Date: September 18, 2023

Facility Name: Beck Landfill

Permit or Registration No.: 1848A

Municipal Solid Waste Permit Amendment No. 1848A
 Beck Landfill
 Fourth Notice of Technical Deficiency

INTERMEDIATE COVER TEMPORARY DOWNCHUTE DETAIL
SCALE: 1"=4'

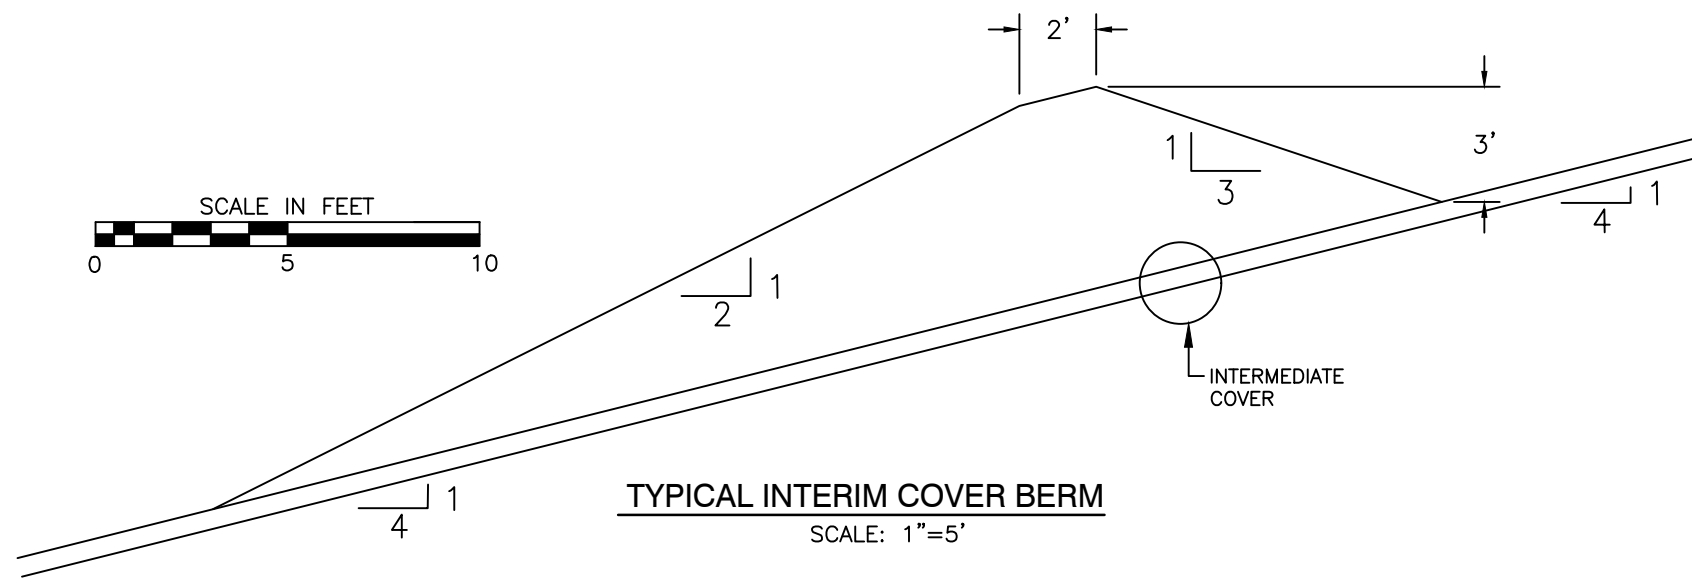
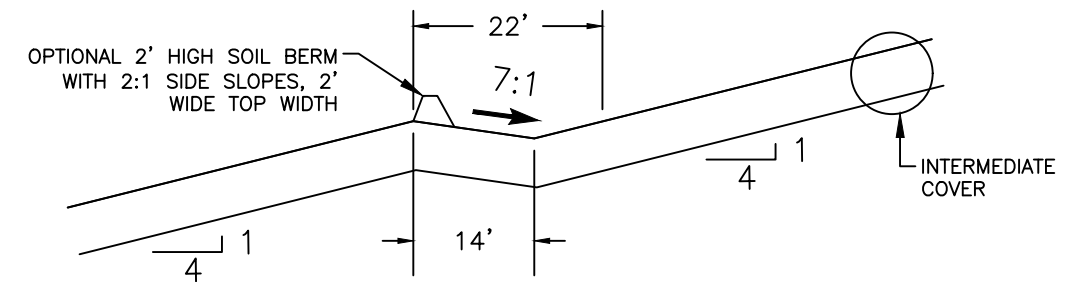
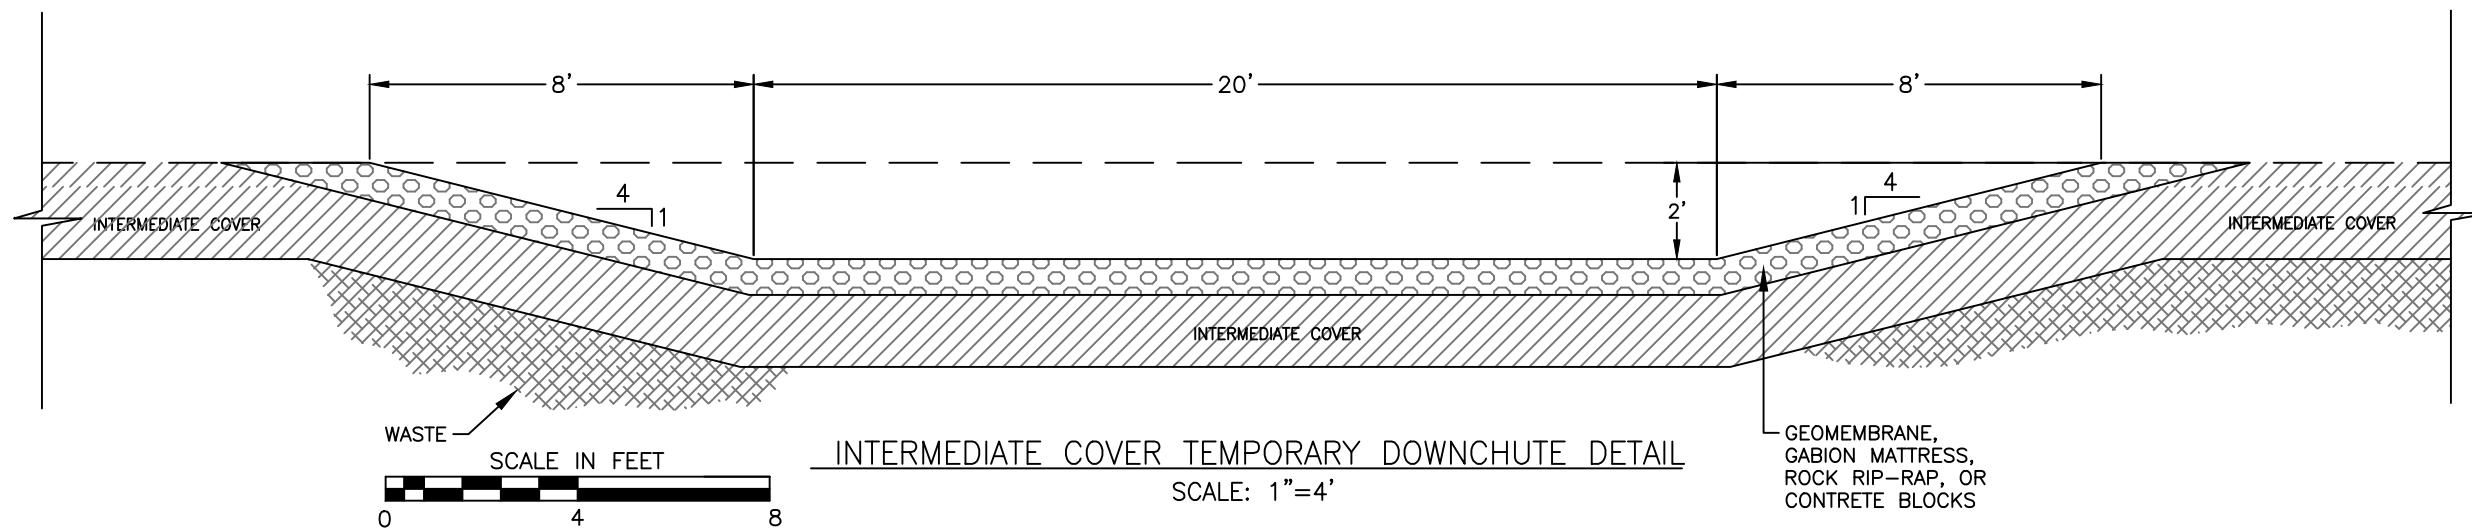
14	313	Part III	330.63(c)(1)(D)(iv)	Appendix C1-D and C1-E	Provide structural design/drawings, including cross-sectional details for the proposed drainage structures (e.g., berm/benches on slopes, chutes, perimeter berms, intersections of chutes and berms, toe of chutes, ponds, etc.) for an interim phase of landfill operation.	Figure C3-4 has been added to Appendix C3 to provide typical details for the proposed interim drainage controls.

All temporary berms shall be designed to minimize erosion and provide a maximum flow depth of two feet. The total height of the berms at the flowline is a minimum of three feet. [A detail for the temporary drainage berm is provided on Figure C3-4, in Appendix C-3.](#) As noted in the calculations, the velocities in the berms are less than permissible non-erodible velocities. If sustained erosion is observed, facility management will evaluate and construct additional temporary drainage berms. Example drainage berm calculations for a grassed intermediate cover are provided below.

The cross-sections for the temporary berms is three feet height, two feet top width, 3:1 uphill sideslopes and 2:1 downhill sideslopes. [A detail for the temporary drainage berm is provided on Figure C3-4, in Appendix C-3.](#) Based on the Rational Method parameters developed in Appendix C1-D, the maximum drainage area allowable for a temporary berm is 15 acres.

The cross-sections for the temporary downchutes is shown above. [A detail for the temporary drainage berm is provided on Figure C3-4, in Appendix C-3.](#) Based on the Rational Method parameters developed in Appendix C1-D, the maximum drainage area allowable for a temporary ~~berm~~downchute is 149 acres.
